Subject: Final Rule, Response to Petitions for Reconsideration, Technical Amendment, Docket No. 2008-0111, Anthropomorphic Test Devices; ES-2re Side Impact Crash Test Dummy 50th Percentile Adult Male.

First Technology Safety Systems (FTSS) has reviewed the February, 2008, ES-2re dummy drawing package (identified in the above mentioned technical amendment) and we have identified a number of drawing errors and a number of drawing issues. We seek to petition NHTSA to correct these drawings to ensure that the ES-2re dummy continues to meet the same dimensional and performance requirements established for the dummy when the dummy was proposed for inclusion into 49 CFR Part 572 Subpart U. FTSS makes the following comments and recommendations with respect to the drawing package. A marked up drawing for each of these recommended changes are attached to the end of this letter.

NATIONAL HIGHWAY TRAFFIC SAFETY ADMINISTRATION	
ILIAC WING ASSEMBLY, RIGHT	
SIZE A1	SHEET 1 OF 1
DRAWING NUMBER 175-6002	REV. B

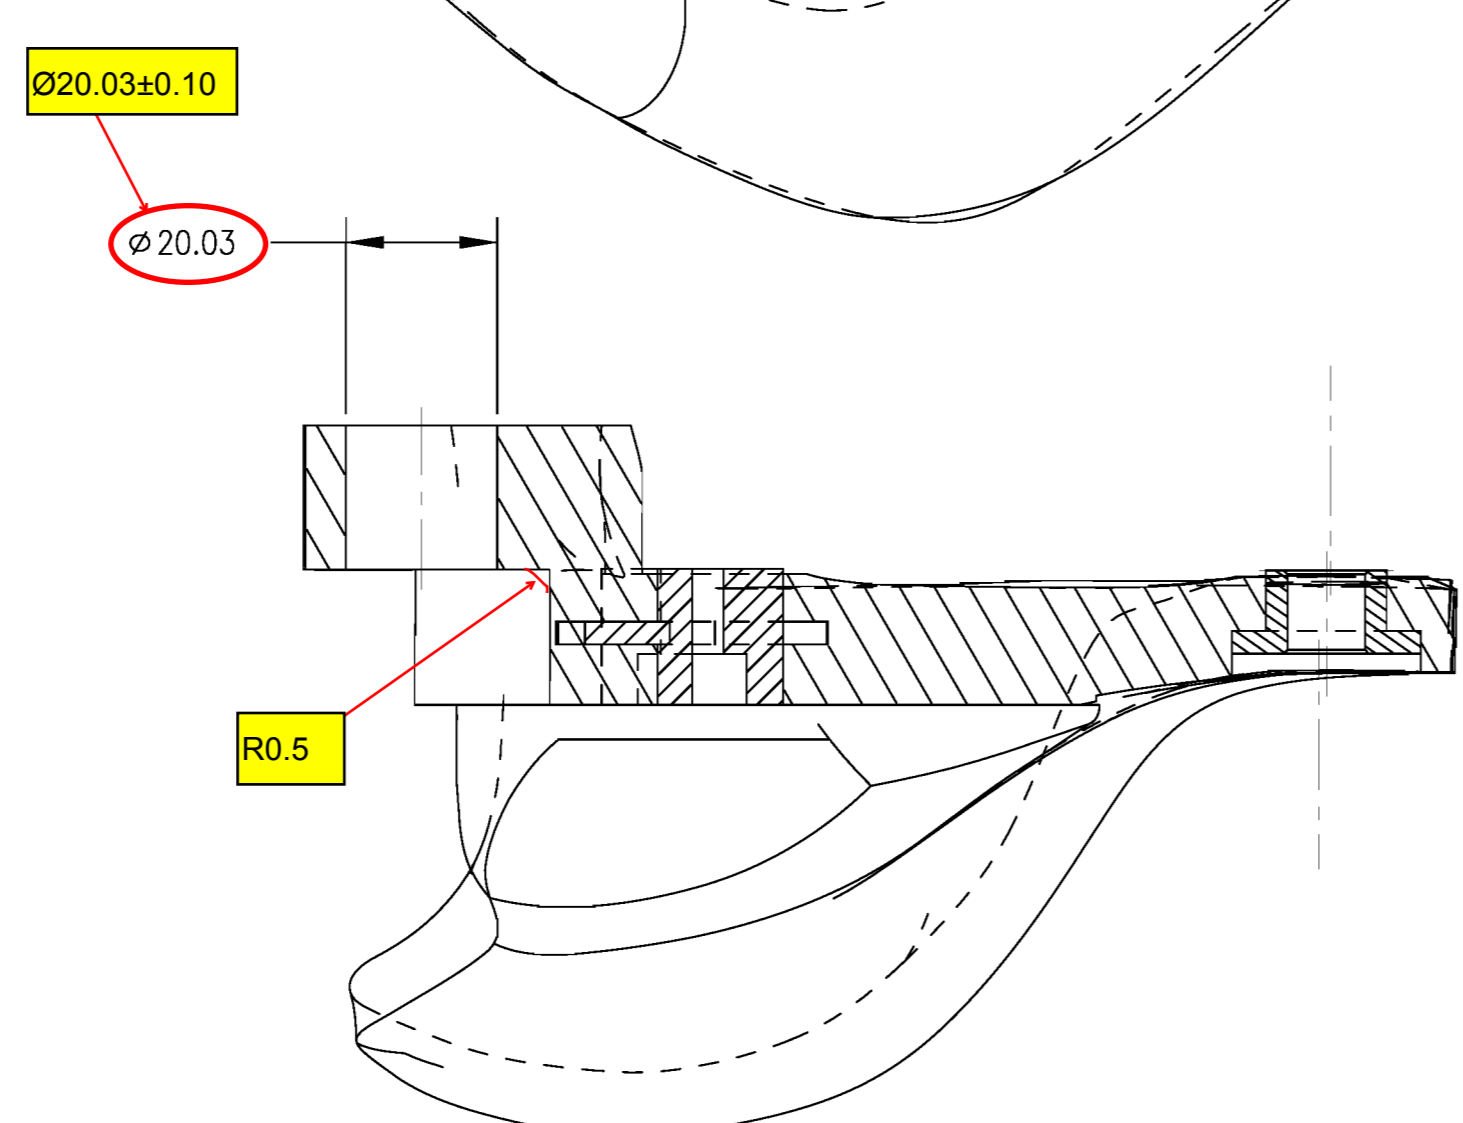
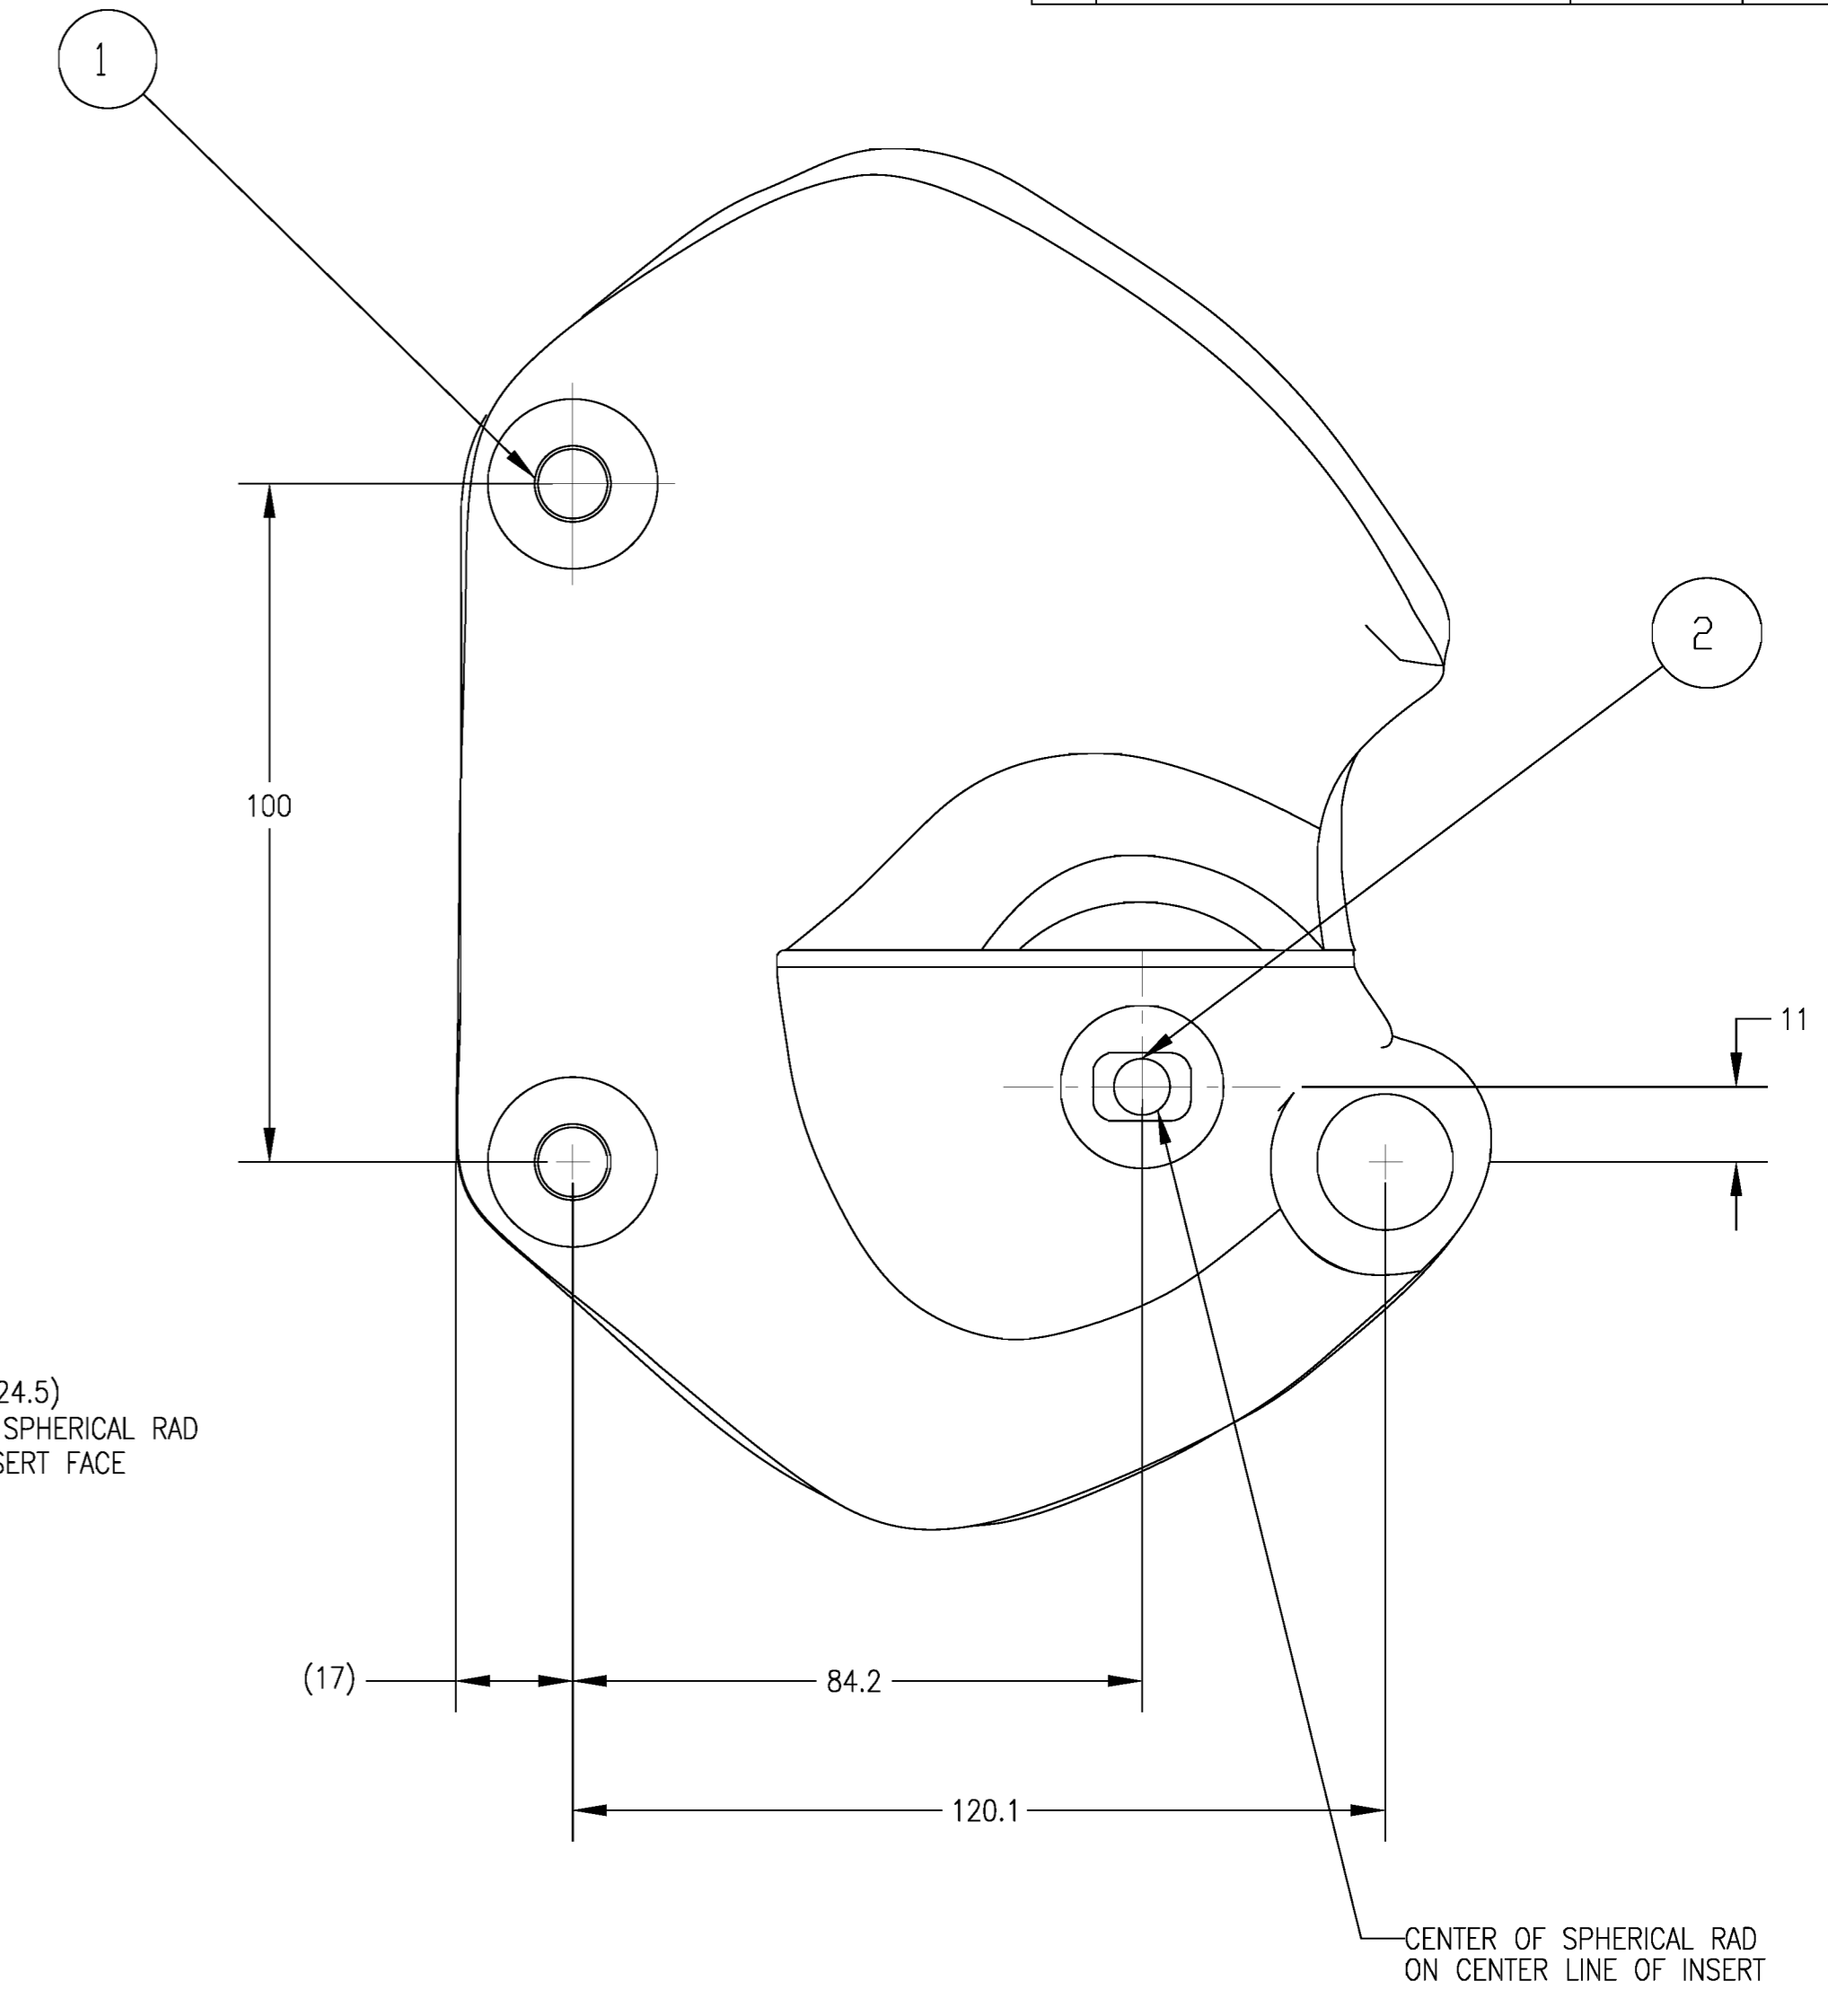
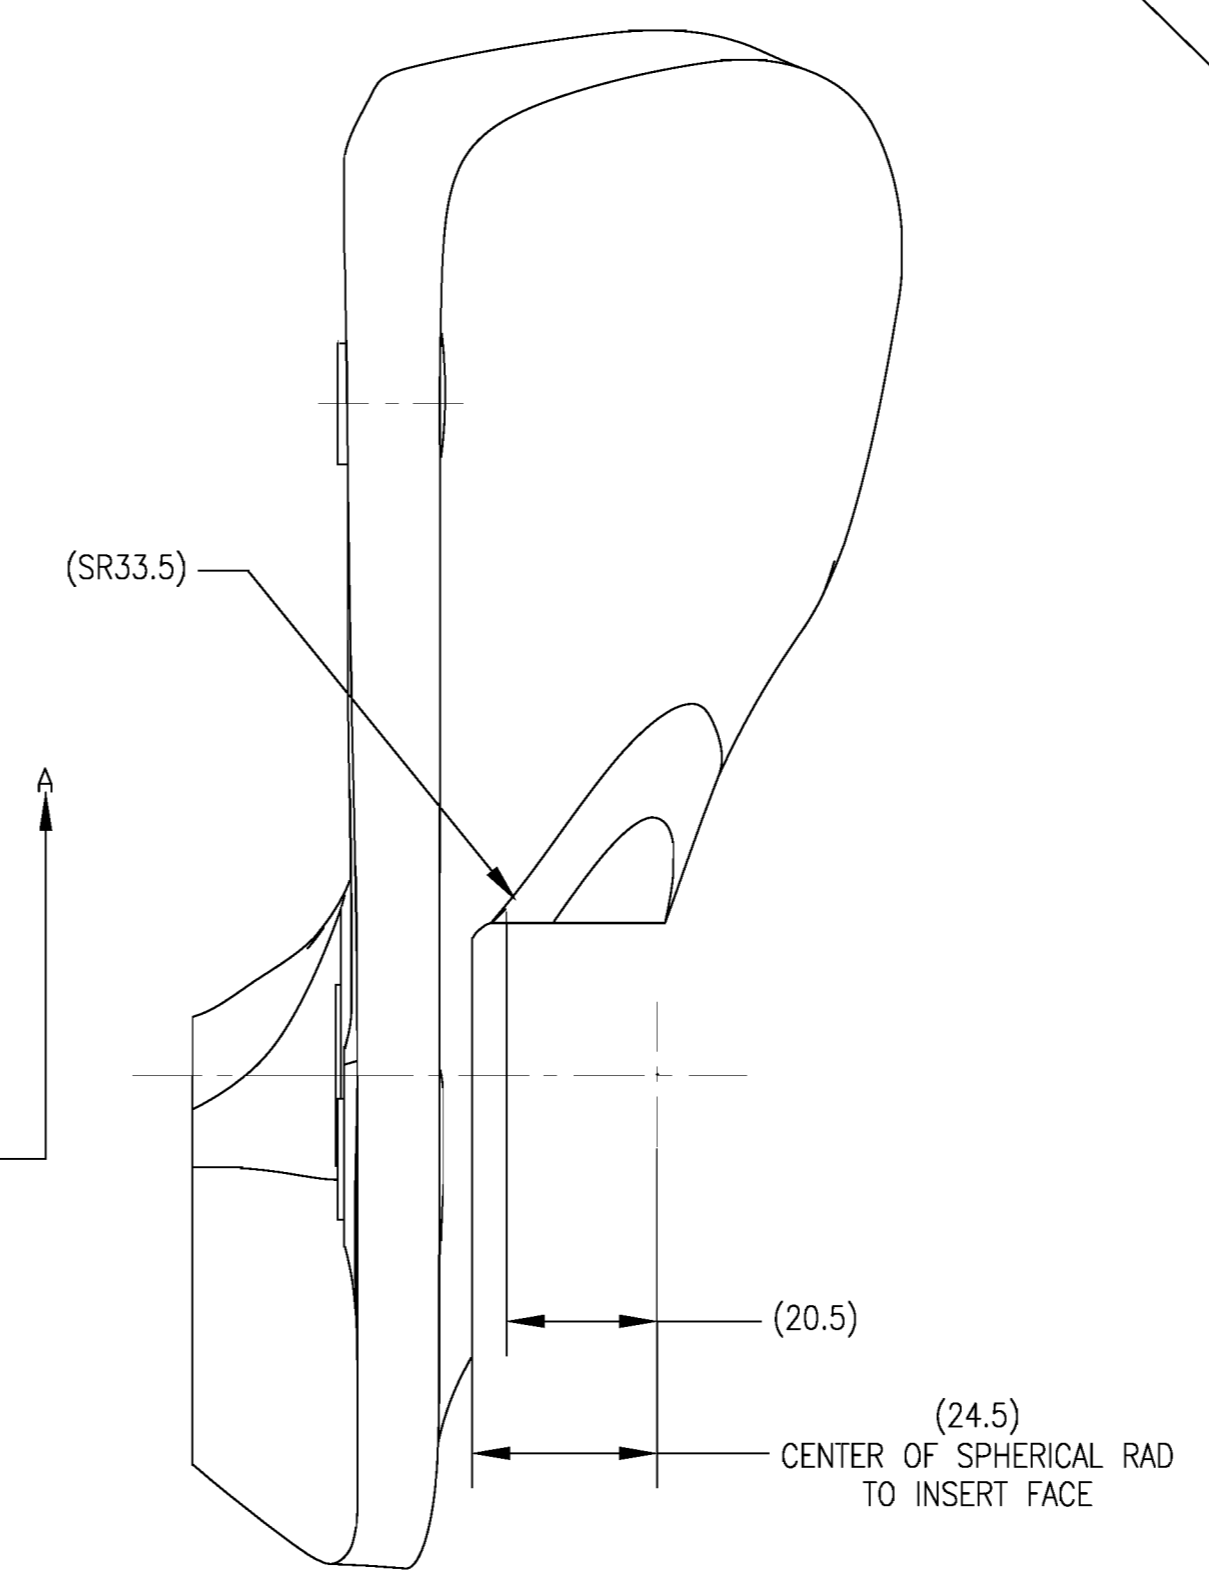
- 8) Drawing 175-6002, Iliac Wing Assembly, Right. FTSS recommends that the drawing dimension $\text{Ø}20.03$ " be replaced with $\text{Ø}20.03 \pm 0.10$ " since this dimension cannot be controlled to ± 0.05 . We also recommend the addition of dimension $R0.5$ " to better define this location for easier machining of this particular section of the part and to prevent breakage due to concentrated stresses.
